**HAI TISEEN PRIMARY HEALTHCARE CENTER
TAMEEM PROVINCE, IRAQ**

SUSTAINMENT ASSESSMENT

**SIGIR PA-08-158
APRIL 16, 2009**

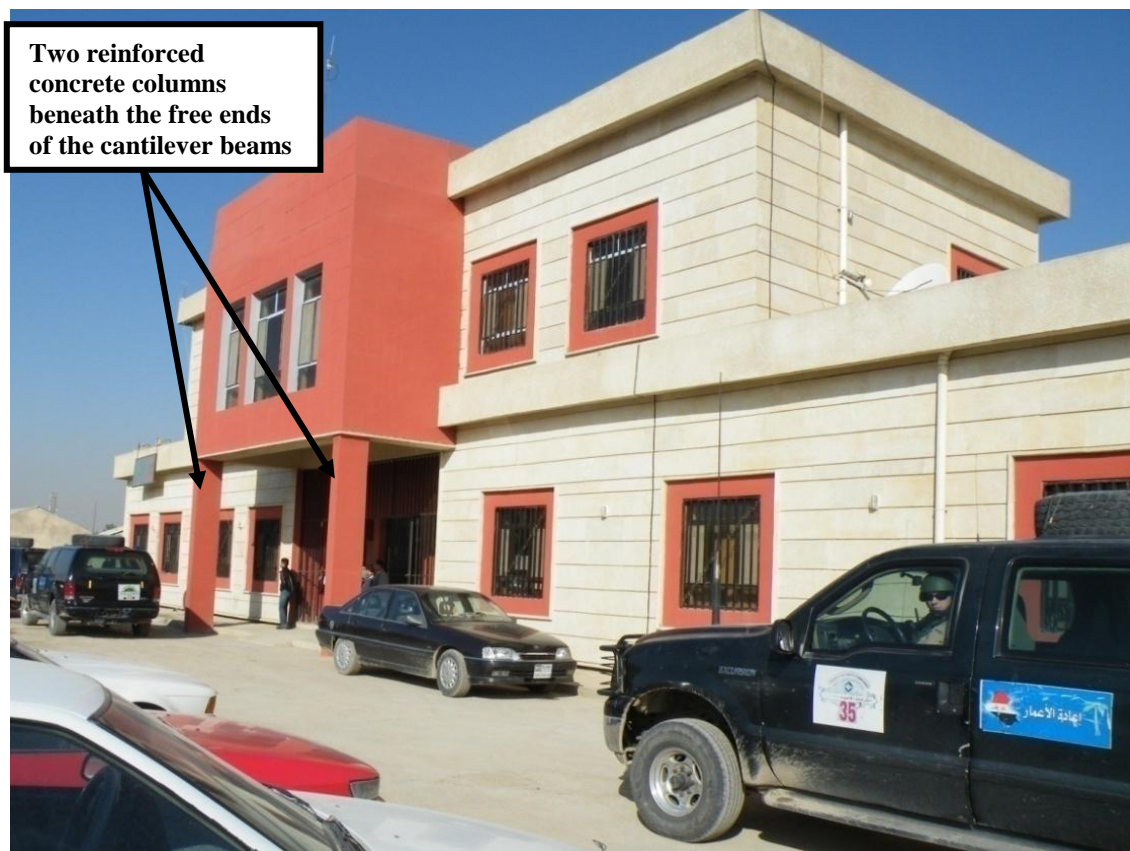
According to project file documentation, on 18 July 2007, the Iraqi Ministry of Health Director General accepted the Hai Tiseen PHC from the U.S. government. The project

file did not contain the final inspection punch list; however, the only notation to the acceptance letter was “x-ray machine will be installed later.”

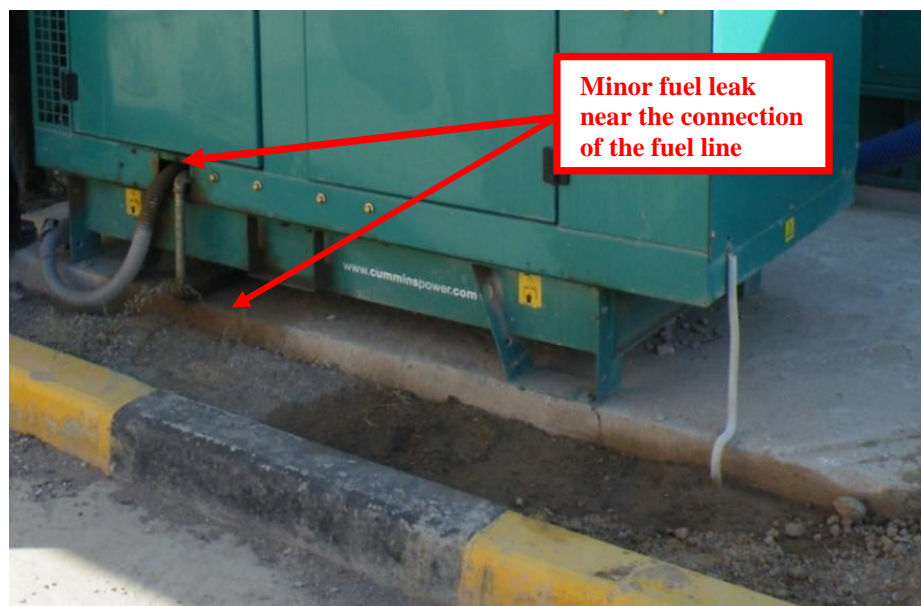
The Hai Tiseen PHC is connected to the national grid; however, the national grid is unreliable and provides approximately four hours of electricity per day. The primary source of electricity for the facility is provided from one of the two generators located on site (Site Photo 5). The larger generator, 1-megawatt (MW), is used for primary power; while the smaller generator, 500-kilovolt (kV), is for emergency backup. During the site visit, the generators appeared to be relatively clean and in working order. SIGIR verified the generators' specifications via the faceplates.

Since the Hai Tiseen PHC is connected to national grid power, an automatic transfer switch is critical to transfer to generator power once electricity from the national grid is lost. The PHC design incorporated the use of an automatic transfer switch. SIGIR verified the installation of the automatic transfer switch, which according to the administrator, was functioning correctly.

SIGIR noticed evidence of a minor fuel leak from the 500-kV emergency backup generator (Site Photo 6). The minor fuel leak was near the connection of the fuel line to the emergency generator and had spread into the soil in front of the generator. This leak presents a potential fire hazard and the PHC's maintenance staff needs to investigate the cause and repair the problem.

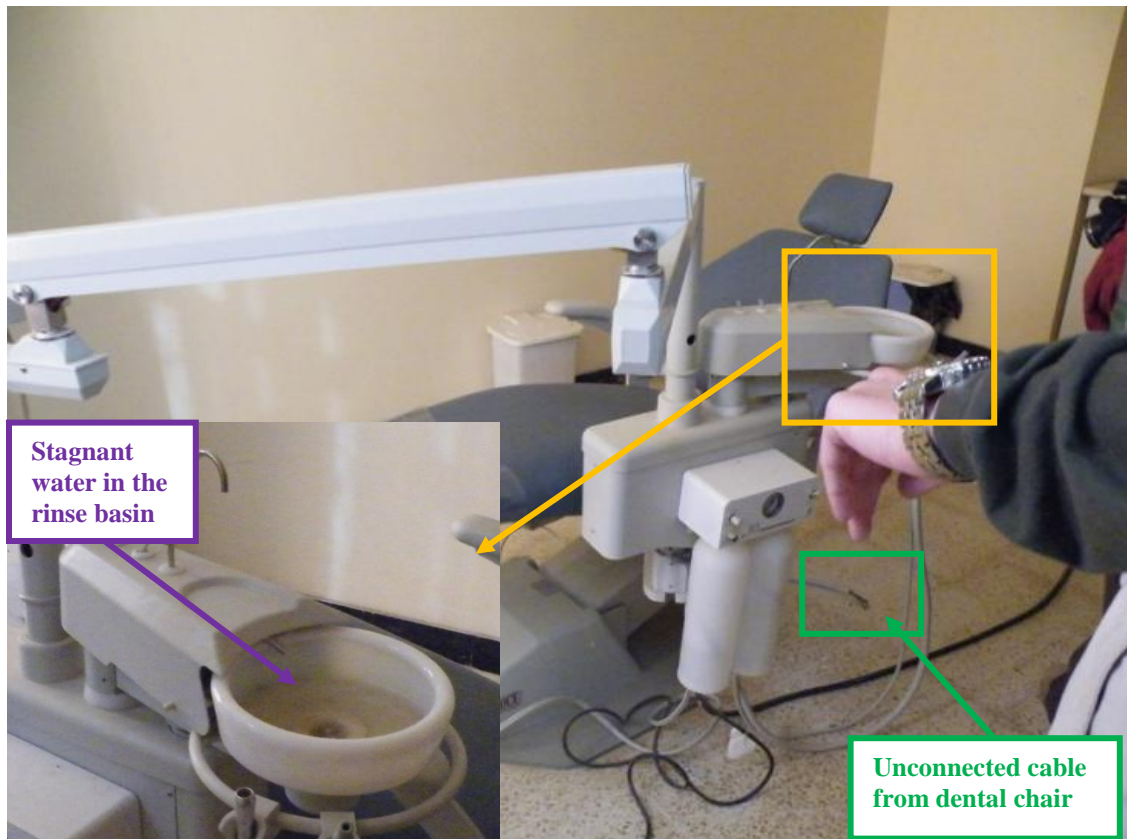
According to USACE's SOP, "Contractors will install/set up medical equipment and commission. USACE representatives shall ensure that commissioning is performed."

During the site visit, SIGIR observed that the dental chairs were installed. While one dental chair appeared to be in use (Site Photo 8), the second dental chair appeared to have a plugged drain with stagnant water in the rinse basin (Site Photo 9). During the inspection, SIGIR observed a dentist treating a patient while using the working dental chair.

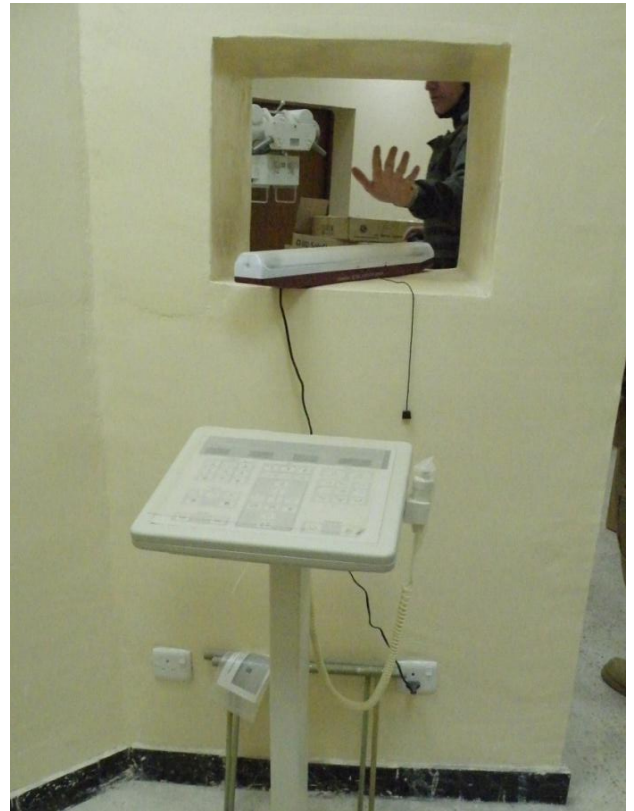
The PHC contract included medical imaging capabilities, specifically an x-ray room and equipment. SIGIR observed that the x-ray equipment was installed (Site Photo 10); however, according to the administrator, the contractor did not verify the equipment was operational. In addition, the administrator stated the facility's staff did not have the technical capability to operate the x-ray equipment; consequently, the facility cannot offer any x-ray services to its patients. Currently, the PHC uses the x-ray room as a medical supply storage room.

Due to the x-ray equipment emitting low levels of radiation, radiation shielding is required to protect the PHC's personnel and patients. The initial design required mass concrete walls with lead lining, lead lined doors, and a leaded glass observation window to provide radiation shielding.

In the 18 July 2007 acceptance letter, one of the noted deficiencies was "x-ray machine," which was to be "installed later." SIGIR noted that the contractor did install the x-ray machine; however, the contract-required installation of a leaded-glass observation window was not installed nor was it noted as a deficiency on the acceptance letter (Site Photo 11). In addition, SIGIR noticed that the contractor installed x-ray room exterior door and darkroom doors appeared to be standard wooden doors. The inspection team could not verify the presence of lead lining on the concrete walls.
